Section 10
AIRCRAFT NAVIGATION EQUIPMENT
Y Series

COMMUNICATION EQUIPMENT MAINTENANCE BULLETIN

SECTION 10. AIRCRAFT NAVIGATION EQUIPMENT

FIGURE 1.—Reconditioning YE antenna and drive mechanism.

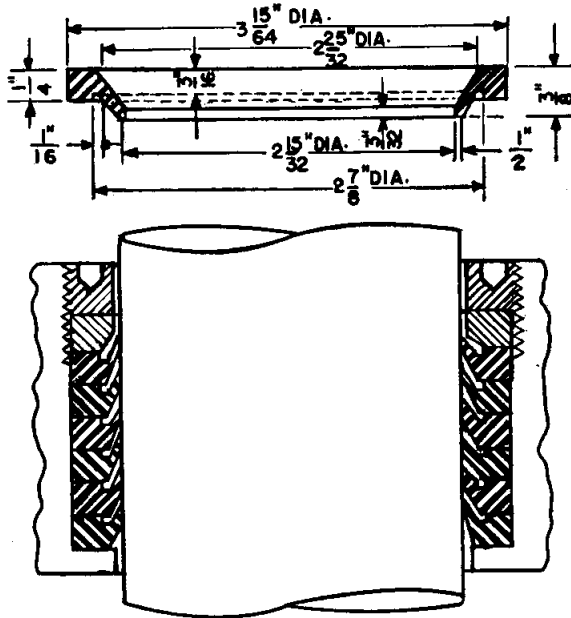
(11) A new type of packing used in the drive unit water seal consists of six specially constructed rings molded from synthetic rubber.

The packing gland box is filled with graphite grease. To install these new type rings, it is necessary to cut off the three extensions on the aluminum gland nut, and to cut a bevel on the inner circumference of the fiber ring to allow clearance for the top packing ring. (See Fig. 1.)

FIGURE 1.—Rearrangement of wiring in the drive unit.

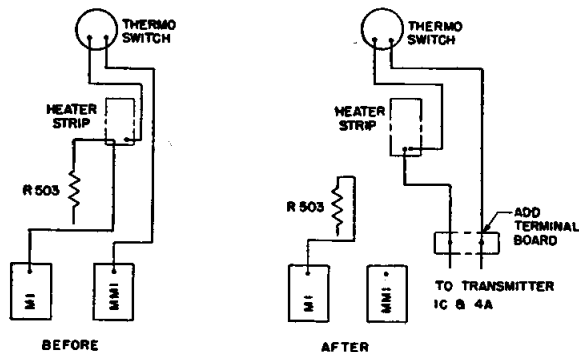
Procedure.—This modification for all types of YE transmitters consists basically in placing the drive unit strip heater and thermo-switch across the same side of the emergency switch S-101 in the transmitter that supplies voltage to the Dow oscillator heater. With the exception of the 230-volt d-c transmitter, the proper voltage can be obtained from terminals 1C and 4A in the transmitter. Refer to the schematic and wiring diagrams of the instruction books.

The wiring in the "drive unit" may be rearranged as shown in Figure 1, with the two ter-

(1) Take cable lead off the left terminal of the heater and connect to rear terminal of resistor R-503.

(2) Take jumper off the rear terminal of R-503 and connect to one side of added terminal block.

(3) Remove lead from MM1 which connects it to the thermo switch and place on other terminal of the added terminal block.

FIGURE 1.—Addition of capacitors to gyro selsyn system.

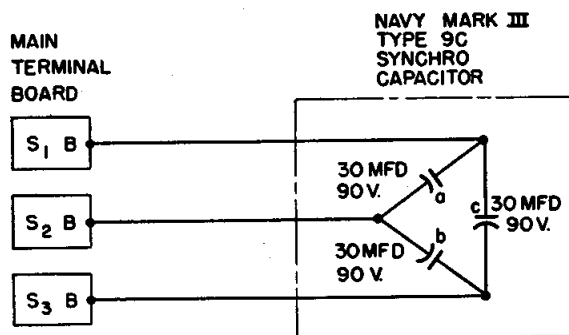
Procedure.—The Navy mark III type 9C synchro capacitor should be mounted externally to the antenna control unit.

The capacitor is connected to terminals S1B, S2B and S3B of the main terminal board of the

control unit as shown in Figure 1. Note that the capacitor is not connected across the ship's selsyn stator bus leads which are connected to terminals CRS1, CRS2, and CRS3. The proper connection places the capacitor bank directly across the differential generator stator leads instead of the ship's stator bus leads and will disconnect the capacitor bank from ship's bus when operated in any position other than GYRO. Otherwise an overload indication would be given for all positions other than GYRO.

FIGURE 1.—Change in over-the-bow keying circuit.

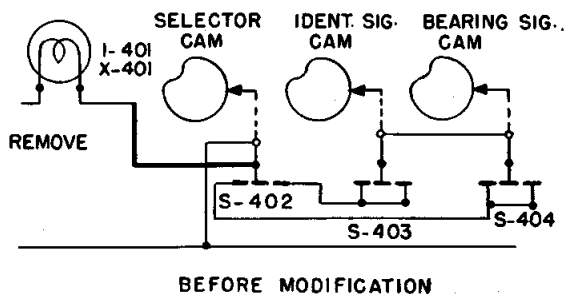
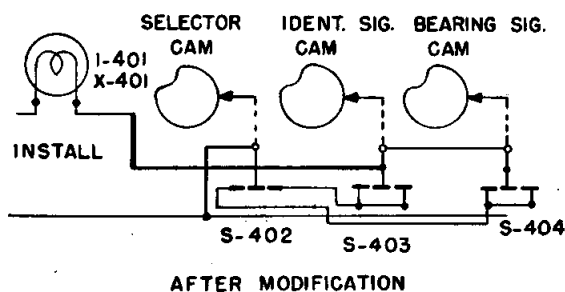
Procedure.—(1) In the antenna control unit Navy type 23271 remove the present lead be-

tween the lamp socket X-401 and the arm of switch S-402 as shown in Figure 1.

(2) Install a new lead between the lamp socket X-401 and the arm of switch S-403 as shown in Figure 2.

FIGURE 1.—Keying modification to eliminate interference.

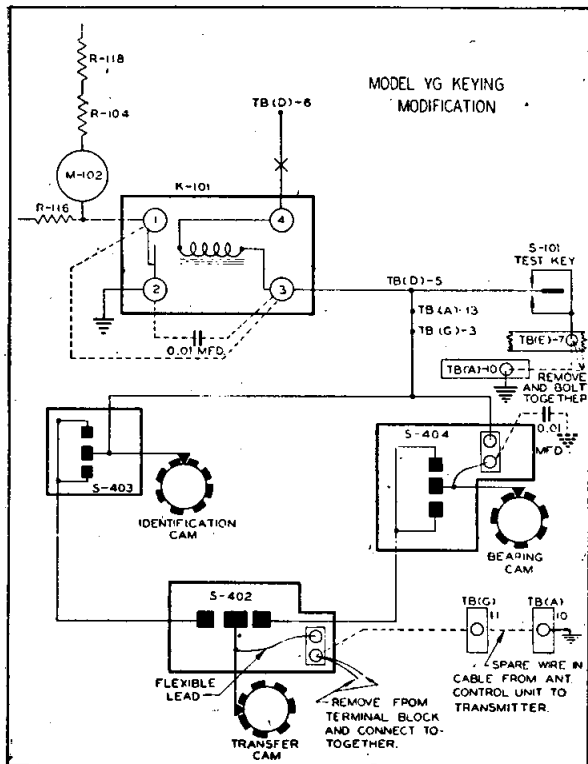
Procedure.—The necessary changes should be made in accordance with the circuit diagram of Figure 1. The broken lines indicate wires which are to be added and an X through a solid wire indicates that the circuit should be broken.

(1) Refer to S-402 in type 23271 control unit: (a) Remove the two inter-unit connections from terminal block of switch S-402.

(b) Bolt together the two leads removed in (a), insulate (tape) for 110 volts AC and lace to associated cable.

(d) Remove keying relay K-101 from the circuit by opening the lead from terminal "4" of relay to terminal "6" of terminal board "D" (marked (X) on the circuit diagram). Do not remove any other wires from the terminals on the relay base.

Note (A).—Provided field change No. 1 has not been accomplished remove this lead and the lead to the a-c line from S-402. Connect these two leads together, insulate (tape) for 110 volts a-c and lace to associated cable.

Note (B).—Provided field change No. 1 has been accomplished, disconnect this lead from S-403 and remove the a-c line lead from S-402. Connect these two leads, insulate (tape) for 110 volts a-c and lace to associated cable. 10/1/46

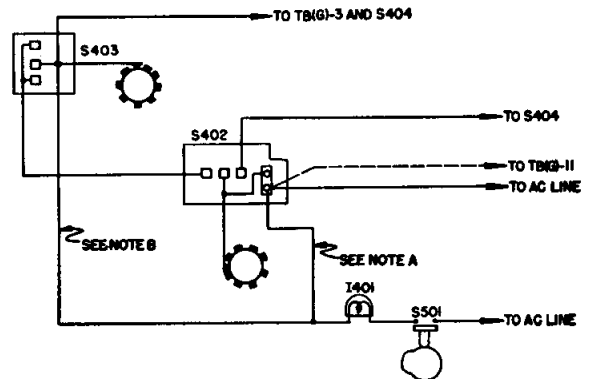
Procedure.—This modification consists of the addition of small washers, preferably fiber, between the resistor connecting links and the bakelite panel in the upper left-hand portion of the YG transmitter.

The fiber washers should be at least $\frac{1}{16}$ " thick, with the outer diameter not greater than $\frac{5}{16}$ ". If these are not available, no. 6 standard metal washers, $\frac{1}{32}$ " thick, with $\frac{5}{32}$ " and $\frac{5}{16}$ " diameters may be used. Two washers are used at each of the following points: Lower terminals of R-109, R-110, R-111, and R-112 and upper terminals of R-102, R-104, and R-118.
